Economic Commission for Europe**Inland Transport Committee****World Forum for Harmonization of Vehicle Regulations****Working Party on Lighting and Light-Signalling****Eighty-second session**

Geneva, 22-25 October 2019

Other UN Regulations:**UN Regulation No. 53 (Installation of lighting and light-signalling devices for L₃ vehicles)****Proposal for a new Supplement to the 03 series of amendments to UN Regulation No. 53****Submitted by the expert from the International Motorcycle Manufacturers Association (IMMA)***

Observing area towards the apparent surface of exterior courtesy lamps

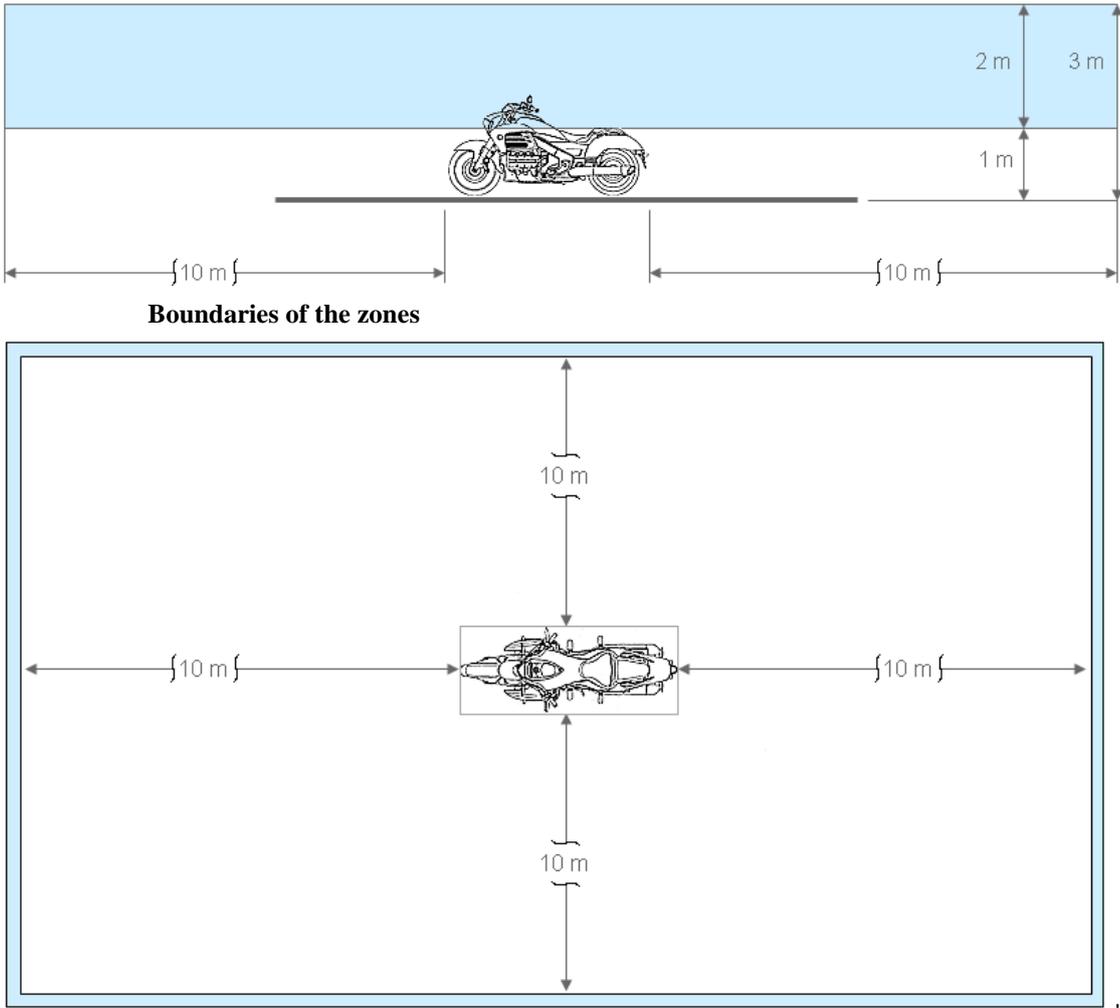
Insert a new Annex 7, to read:

This drawing shows the zone from one side, the other zones are from the front, the rear and from the other side of the vehicle.

observer moving on the boundary of a zone on a transverse plane 10 m from the front of the vehicle, a transverse plane 10 m from the rear of the vehicle, and two longitudinal planes 10 m from each side of the vehicle; these four planes to extend from 1 m to 3 m above and perpendicular to the ground as shown in Annex 7.
